APPLICATION

From: Bricker, Robert
Sent: Wednesday, September 04, 2013 1:33 PM
To: 'jwkmasters@aol.com'
Subject: FW: notes for perc cert
Attachments: perc cert notes_example.doc

PERCOLATION CERTIFICATION PLAN

14859 Michele Dr.
Glenelg, MD 21737

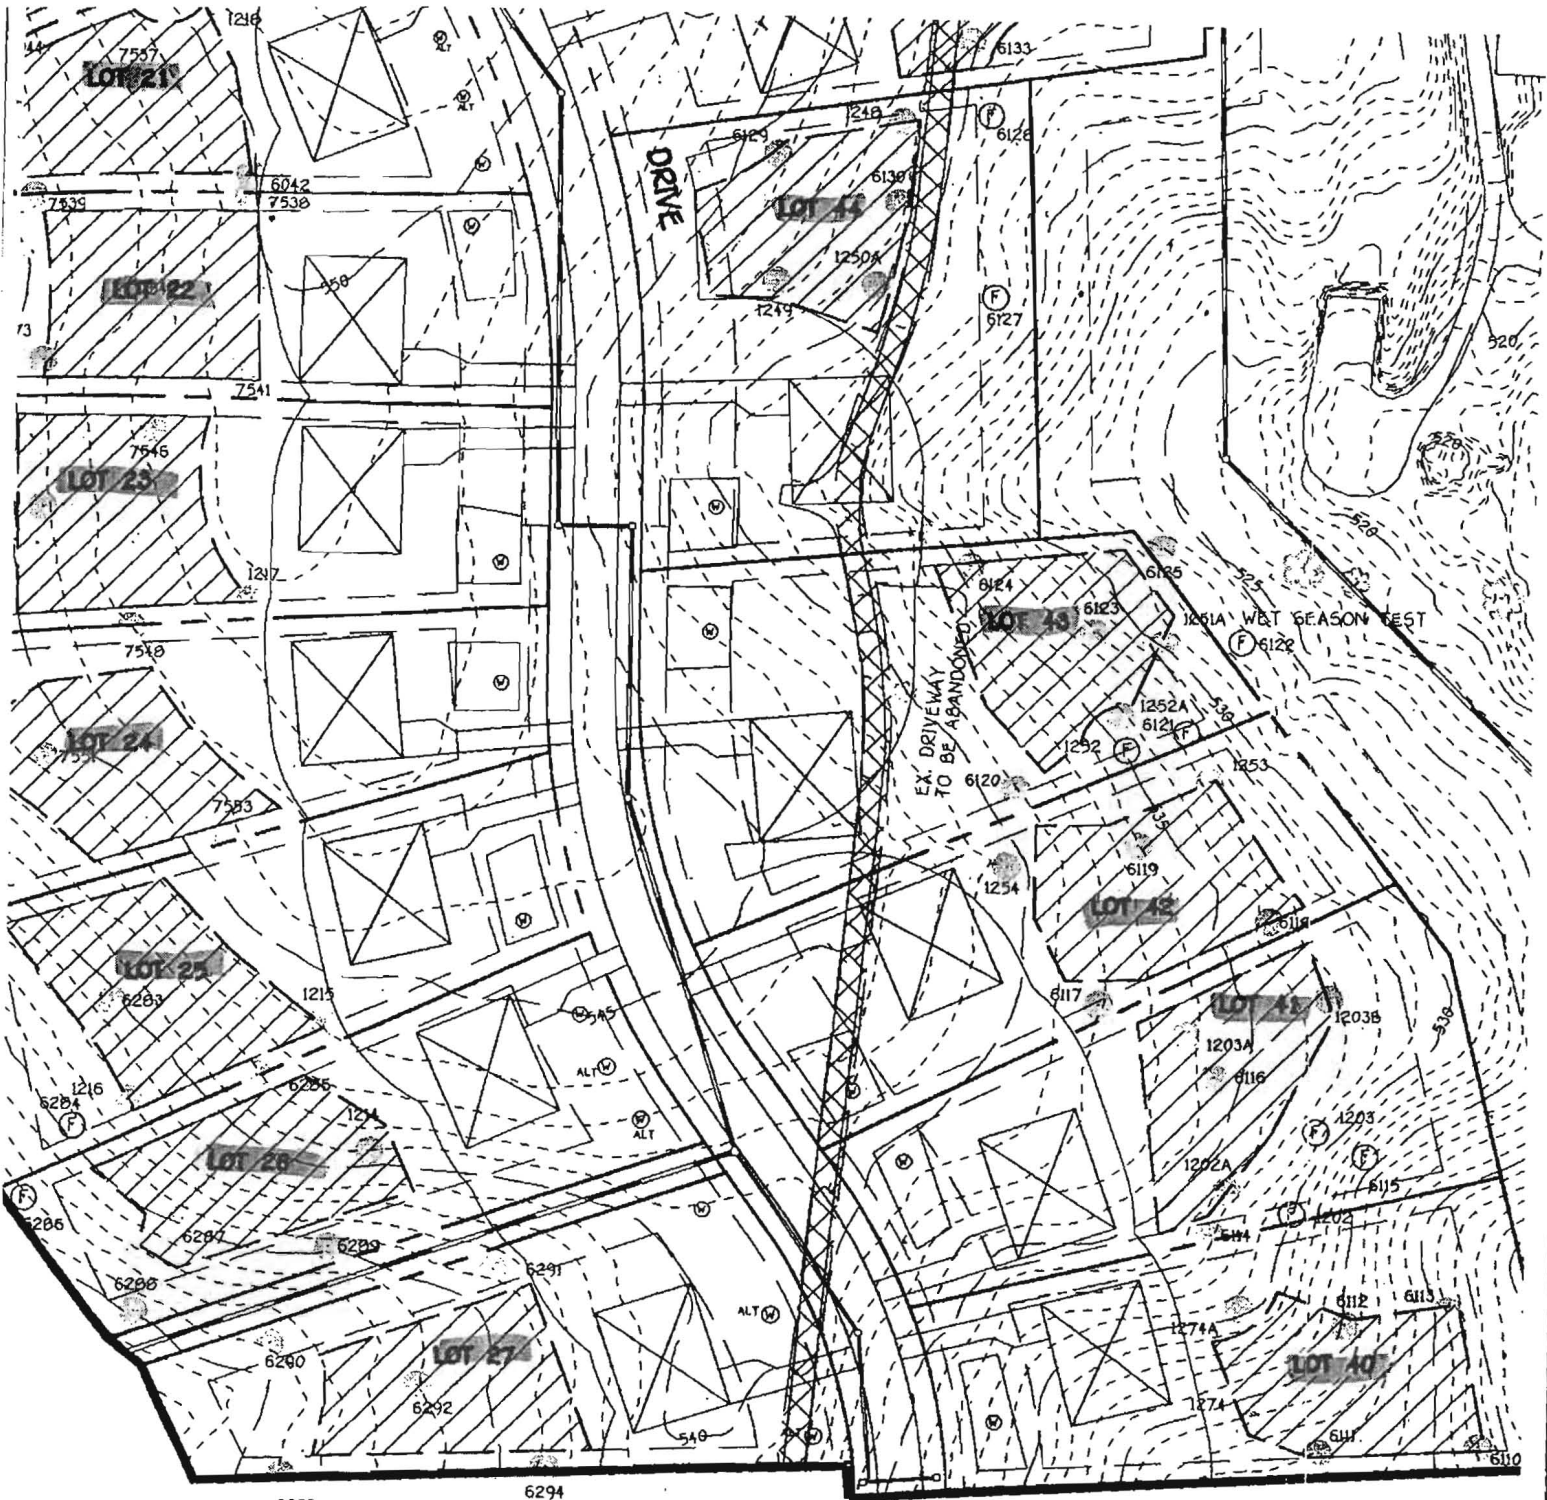
REMARKS ALL HOLES PER PLAN, SUGGEST RETEST 50' UPHILL OF 6286

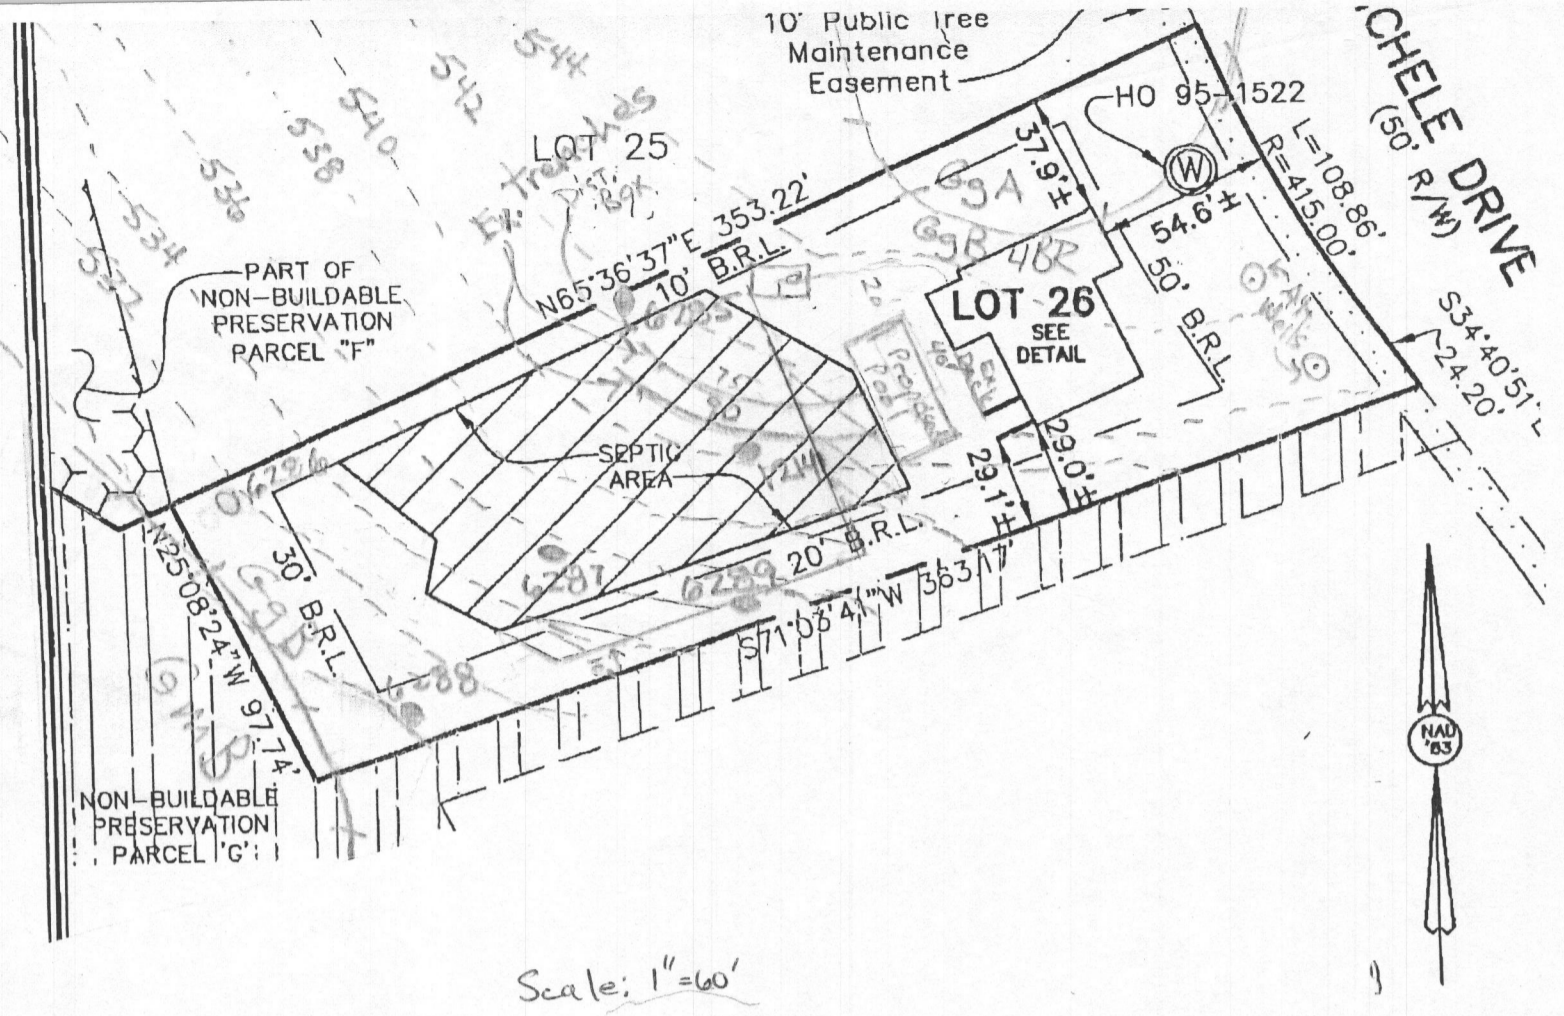
John,
Additional information is being required on your Percolation Certification Plan, specifically additional notes. Our Asst Director is requiring that the modification of trenches be more descriptive, i.e., describing in the notes that 40 feet of trench is to be removed and replaced. Also that the gravel is removed from several feet (3' – 5') of the existing trenches where the pipes are severed, and soil packed back into the void thereby creating a barrier limiting the flow of solution toward the pool area. He wants everyone (sanitarians, contractors, owner) to be clear about what is expected in modifying the septic system to accommodate the pool site.

A new trench, 40 feet in length, is to replace the approximate 40 feet of trench to be abandoned. At the cut ends of the two existing trenches, gravel is to be completely removed for a length 3 to 5 feet and soil is to be tamped back into the void.

The property owner, or designee, is responsible for accurately marking the proposed location of the inground pool basin prior to the septic contractor's layout inspection.

*9. A new trench, 40 feet in length is to replace the approximate 40 feet of trench to be abandoned. At the cut ends of the existing trenches, gravel is to be completely removed for a length of 3 to 5 feet and soil is to be tamped into the void.

*10. The owner, or designee, is responsible for accurately marking the proposed location of the inground pool basin prior to the septic contractor's layout inspection.

*Notes 9 and 10 inserted with owner's permission.
reB 9/1/2013
